JOSEPH M. FARLEY NUCLEAR PLANT, UNIT NO. 1

AMENDMENT TO FACILITY OPERATING LICENSE

Amendment No. 53
License No. NPF-2

ATTACHMENT TO LICENSE AMENDMENT NO. 53
AMENDMENT NO. 53 FACILITY OPERATING LICENSE NO. NPF-2
DOCKET NO. -50-348

Figure 6.2-1 Offsite Organization for Facility Management and Technical Support

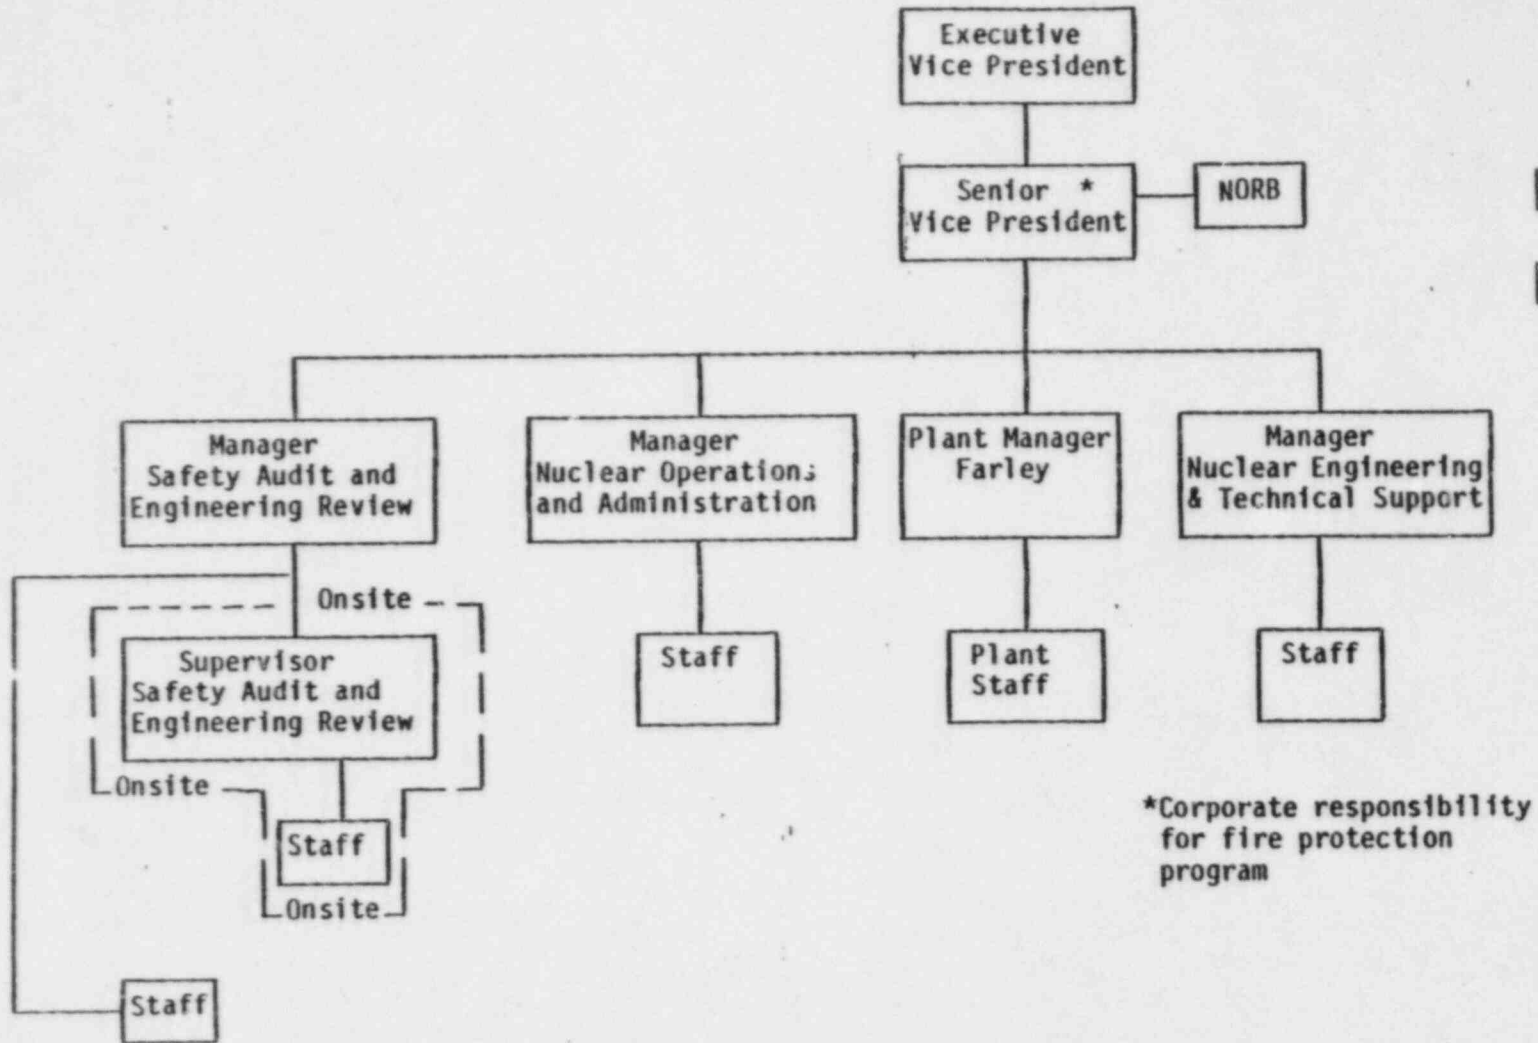
6.2.1 The offsite organization for facility management and technical support shall be as shown on Figure 6.2-1.

Figure 6.2-1 Offsite Organization for Facility Management and Technical Support

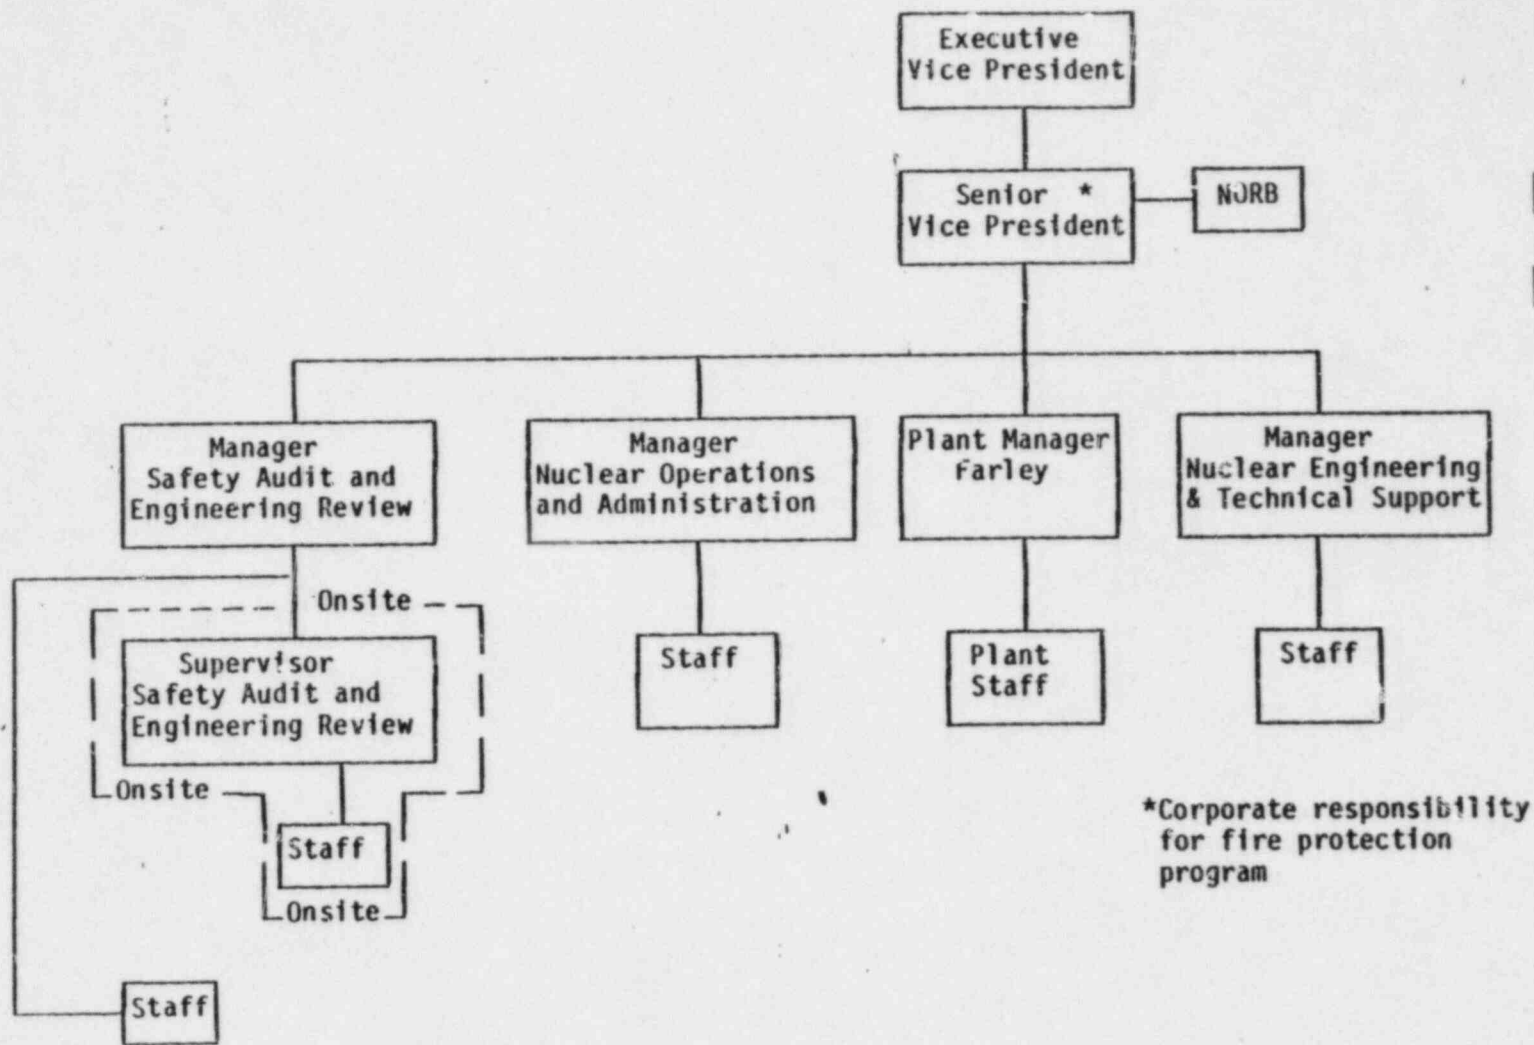
6.2.1 The offsite organization for facility management and technical support shall be as shown on Figure 6.2-1.
